DART SERVICE INSTRUCTION

TO AMEND INSTALLATION INSTRUCTIONS IIN-D407-781-2 REV. A OR LATER APPROVED REVISION
AND INSTRUCTIONS FOR CONTINUED AIRWORTHINESS ICA-D407-781 REV. 3 OR LATER REVISION

REF. TCCA STC: SH08-60
REF. FAA STC: SR002726NY
REF. EASA.IM.R.S.01541

A	NEW ISSUE		13.04.08
REV.	DESCRIPTION	BY	DATE
DESIGN			
DRAWN			
CHECKED			
MFG. APPR.	N/A		
APPROVED			
DE APPR.			
DATE	13.04.08		
DART AEROSPACE LTD HAWKESBURY, ONTARIO, CANADA		REV. A SHEET 1 OF 2	
DRAWING NO. DSI 9649		SCALE NTS	
TITLE ALTERNATE INSTALL			
COPYRIGHT © 2013 BY DART AEROSPACE LTD. THIS DOCUMENT IS PRIVATE AND CONFIDENTIAL AND IS SUPPLIED ON THE EXPRESS CONDITION THAT IT IS NOT TO BE USED FOR ANY PURPOSE OR COPIED OR COMMUNICATED TO ANY OTHER PERSON WITHOUT WRITTEN PERMISSION FROM DART AEROSPACE LTD.

**FIGURE 1 - D3879-1 BAGGAGE COMPARTMENT WALL
PROTECTOR - ALTERNATE INSTALLATION**

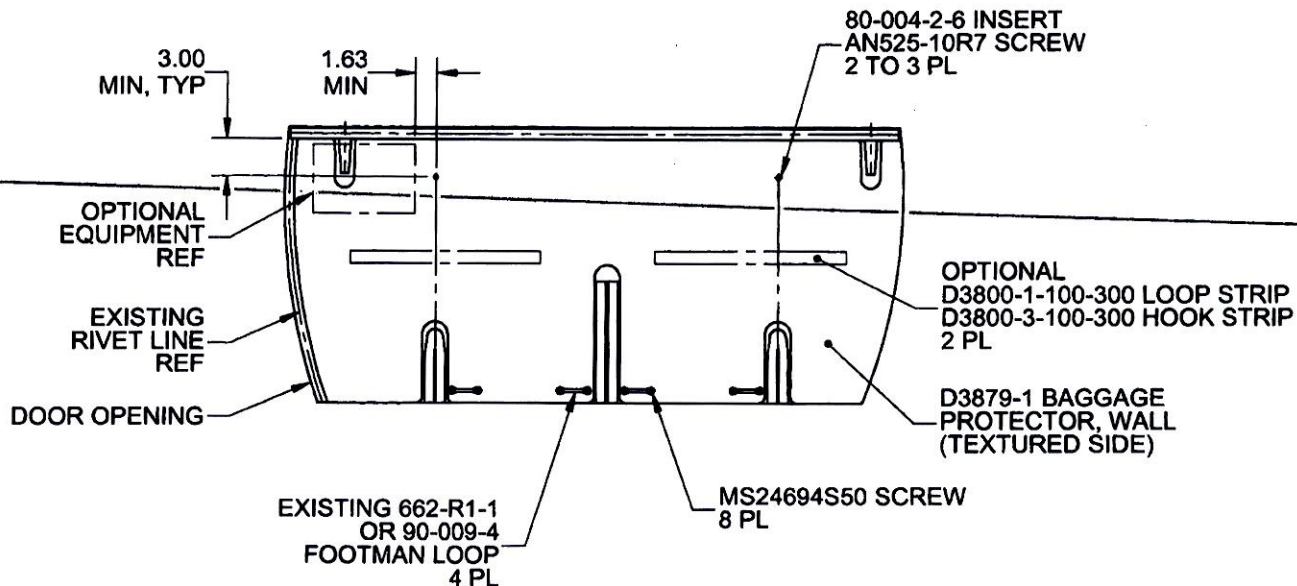
In some aircraft, the top portion of the D206-781-041 Baggage Compartment Wall Protector Kit cannot be installed as indicated in IIN-D407-781-2. The purpose of this DSI is to provide an alternate mounting method to fasten the top portion of the D206-781-041 Baggage Compartment Wall Protector Kit.

It is acceptable to replace qty(2) D3930-1 Clips with qty(2) 80-004-2-6 Inserts. Locate and mark location of the two attachment holes on the baggage compartment wall as shown in Figure 1 of this service instruction. Install 80-004-2-6 Inserts at the marked locations in accordance with Section 3-2-12 of BHT-206-SRM-1. It is acceptable to trim the wall protectors to accommodate optional equipment or transfer attachment holes to the wall protector and install the optional equipment on top of the wall protector with longer fasteners.

Amend the D206-781-041 Baggage Compartment Wall Protector Kit parts list as follows:

Qty -061	Qty -031	Qty -041	Part Number	Description
X			D206-781-061	BAGGAGE COMPARTMENT PROTECTOR KIT (FLOOR AND WALL)
1	X		D206-781-031	BAGGAGE COMPARTMENT FLOOR PROTECTOR KIT
1		X	D206-781-041	BAGGAGE COMPARTMENT WALL PROTECTOR KIT
		2	AN525-10R7	SCREW
		2	80-004-2-6	INSERT
